SUBJECT: Forwards "Foundation Instrument Rept," response to SER
 Section 2.5.4.3 & summary of 811020-21 meeting.

Subject: Palo Verde Nuclear Generating Station
(PVNGS) Units 1, 2 and 3
Docket Nos. STN-50-528/529/530
File: 81-056-026; G.1.10

SETTLEMENT MONITORING

FIGURE 2

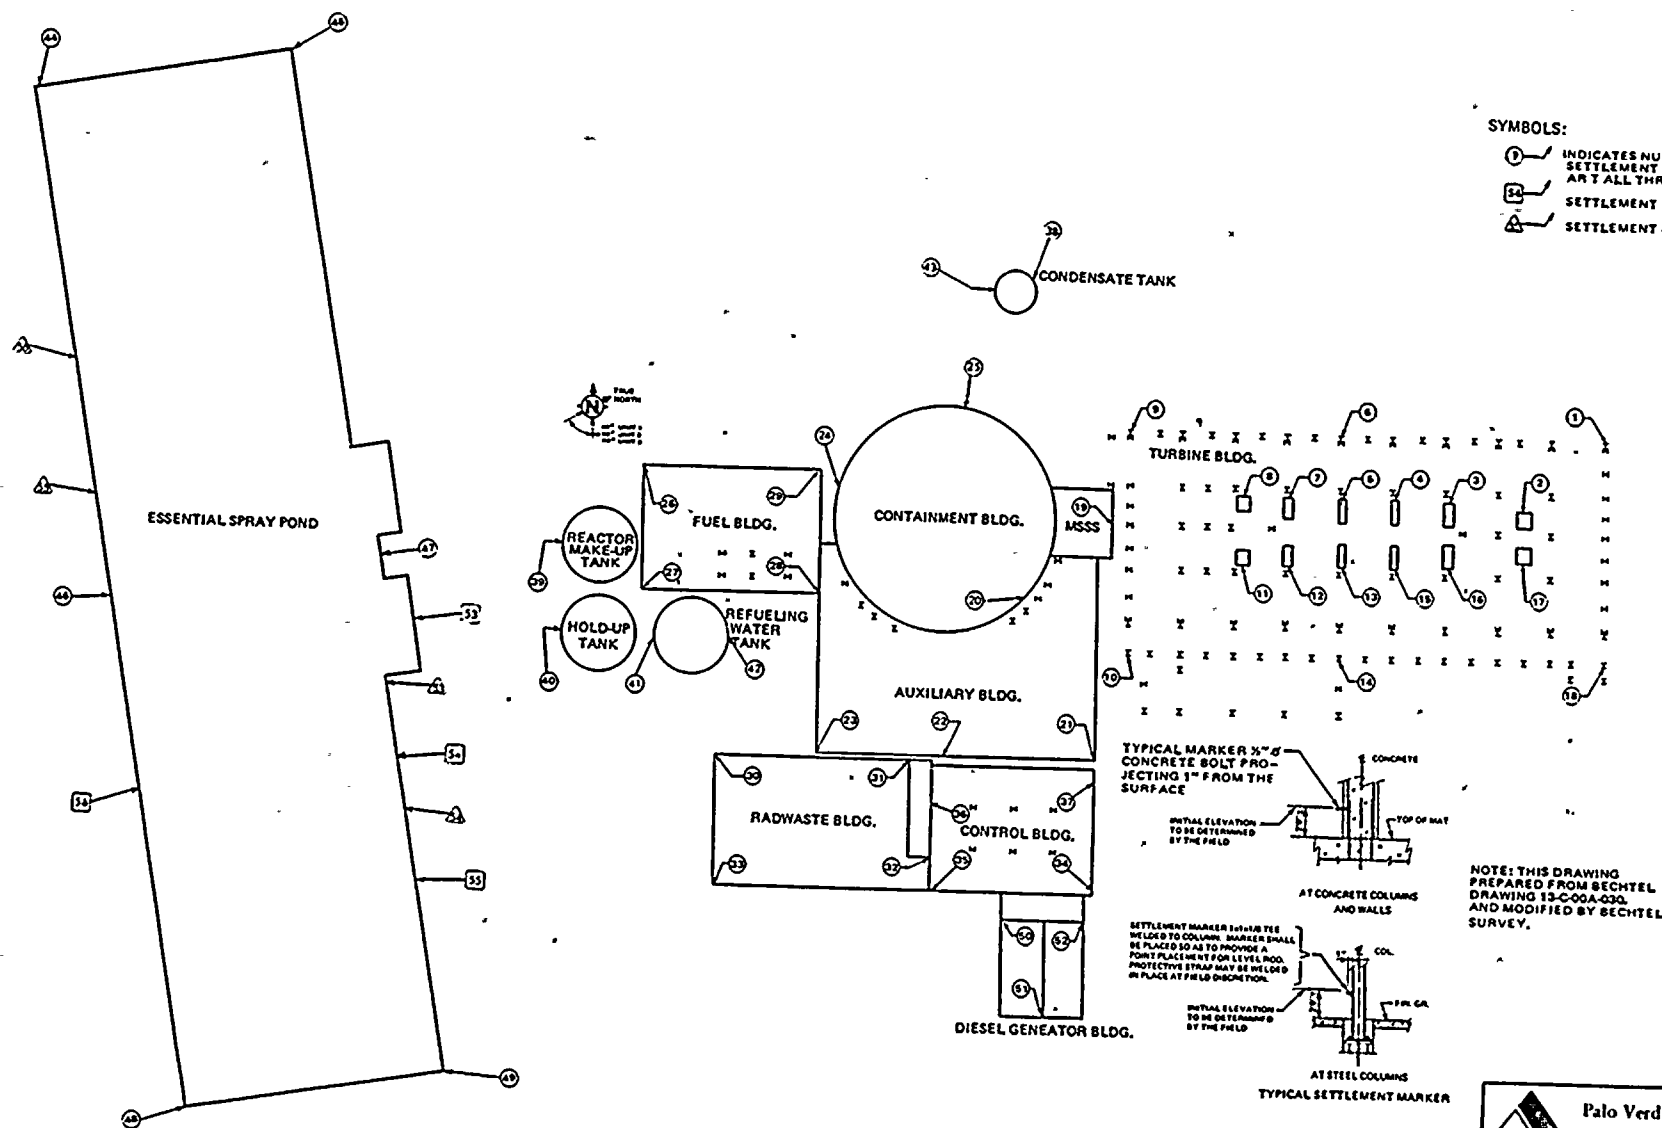
- a) Increase the frequency of post construction settlement monitoring.
- b) Add three monitoring points to the essential spray pond structural fill area.
- c) Include Items a) and b) into the monitoring program for Units 1, 2 and 3.

- a) Refer to the revised FSAR Table 2.5-18 (Attachment 2).
- b) Locations for four additional settlement marker monitoring points per unit have been selected to monitor settlements of backfill supported segments of the spray ponds. These locations are shown on revised Figure 2 (Attachment 3) to our Foundation Instrumentation Report.
- c) Items a) and b) have been incorporated as part of our heave, settlement and subsidence monitoring program for Units 1-3. Refer to the revised Foundation Instrumentation Report (Attachment 4).

AVERAGE LATERAL PRESSURE DUE TO ADJACENT SURCHARGE FOR RIGID
RETAINING WALL
FIGURE 3H-1

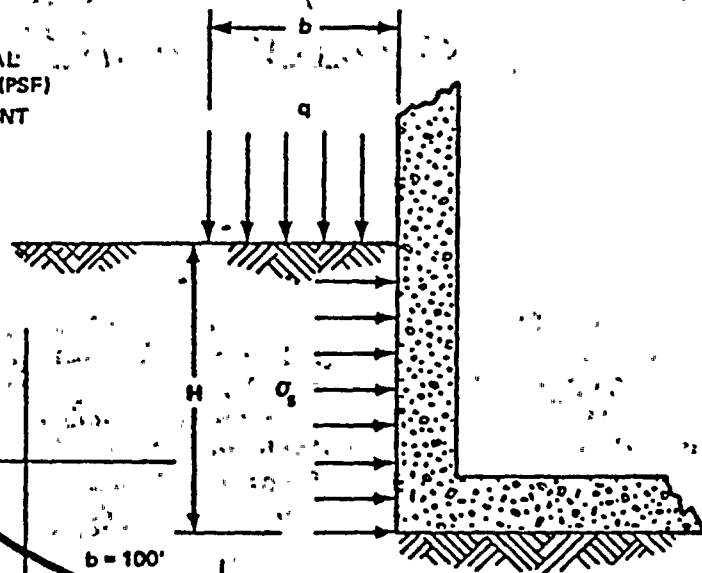
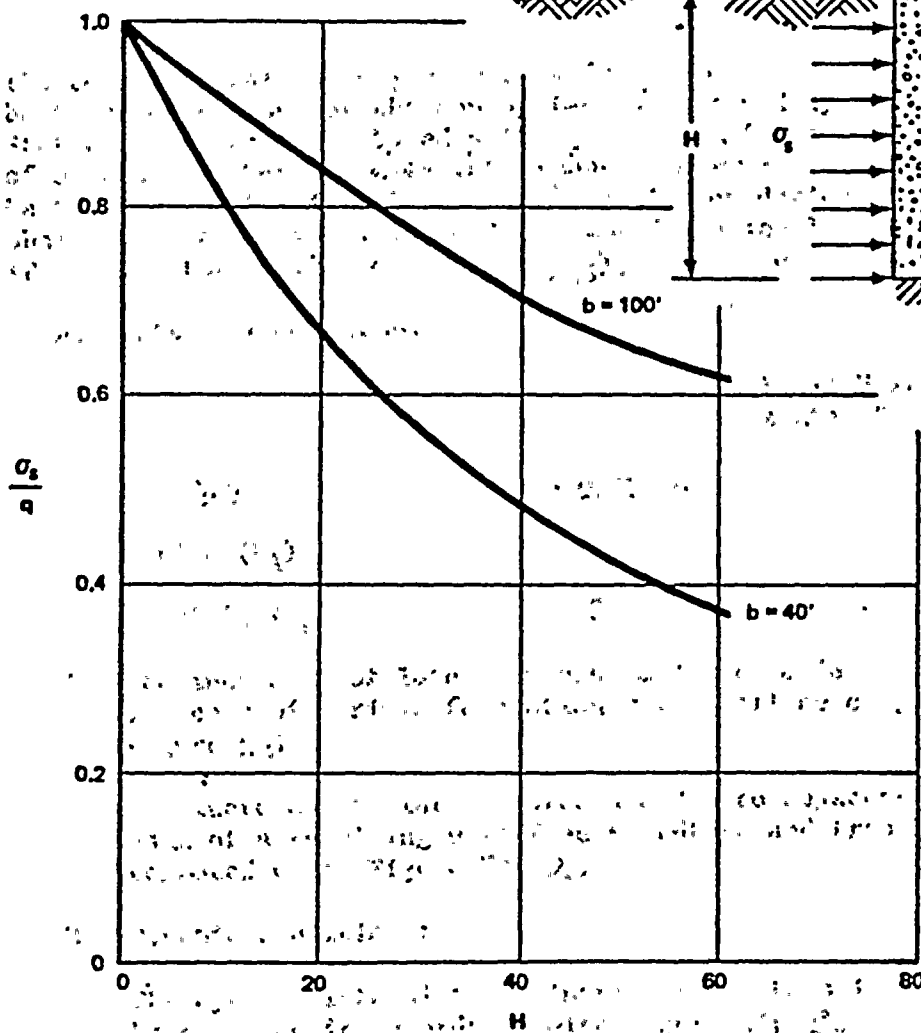
→ APS will provide the design criteria for lateral earth pressures and incorporate into the FSAR, Section 3.8. (Currently there is no mention of surcharge effects.)

The increment of lateral pressure due to adjacent surcharge for the case of a rigid foundation wall shall be computed using Figure 3H-1.

FIGURE A-1 CASES ANALYZED

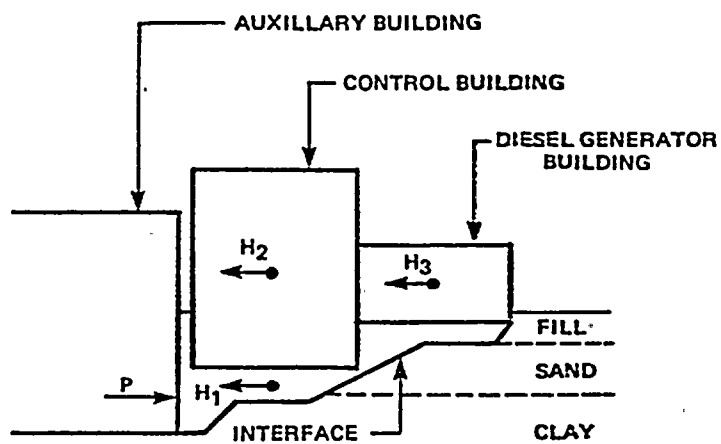
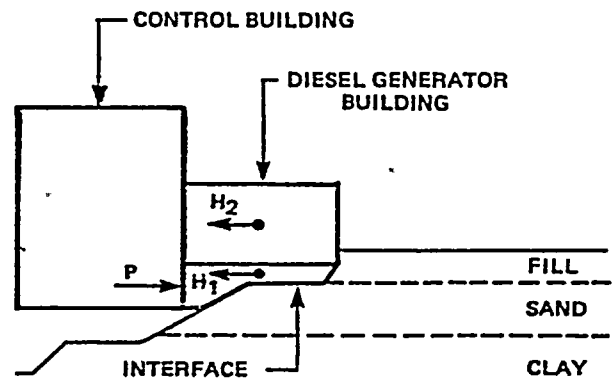
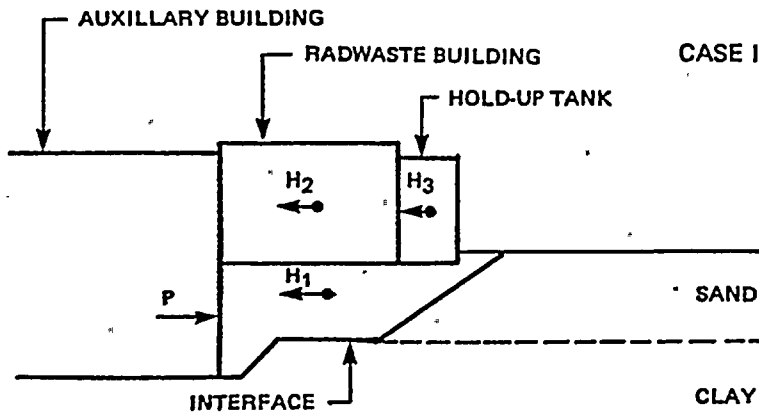
Provide an updated stability analysis with reasonably conservative interpretation of shear strength along the backfill to native soil interface.

The potential effects of hypothetical weak zones along the backfill to native soil interfaces on dynamic lateral earth pressures were evaluated by pseudo-static analyses. Three cases, depicted in Figure A-1, were analyzed. These cases represent the most adverse lateral loading conditions for Category 1 Structures.

The results of the analysis as well as the loading conditions that were analyzed are presented in Table A-1. It can be seen that in all three cases the shear stress that needs to be mobilized along the backfill to native soil interface is a small fraction of the full shear strength of the soils involved. This confirms that the dynamic lateral earth pressures would not be significantly affected by the assumed presence of weak zones along the backfill to native soil interfaces. Furthermore, as noted in our original response to Question No. 241.3, there is no reason to suspect the presence of such weak zones along the backfill to native soil interfaces at the Palo Verde Nuclear Generating Station.

FIGURE B-1 ADDITIONAL SHAKE ANALYSES

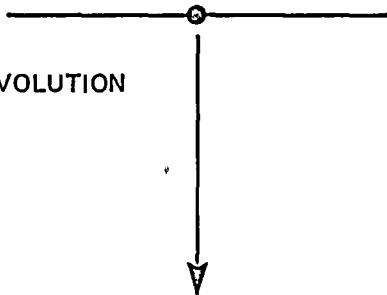
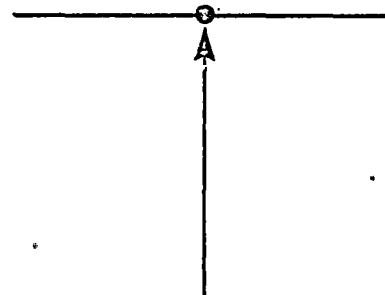
Provide results of an additional SHAKE analysis to verify that a surface motion derived from a deconvolved deep motion would be the same as the original surface motion.

Input Data. Two additional computer solutions were carried out to demonstrate that the motion is uniquely defined. The procedure in which this demonstration was performed is shown schema-

During the analyses the Bechtel artificial earthquake record scaled to 0.2g was assigned at the surface in the first run. The base motion obtained at the 100-foot depth in the first run was then fed back into the base of the soil column in the second run to obtain another surface motion. The original input motion and the output (surface) motion from the second run were subsequently compared in terms of time histories of acceleration, response spectra for 2 and 5 percent damping, and induced shearing stress.
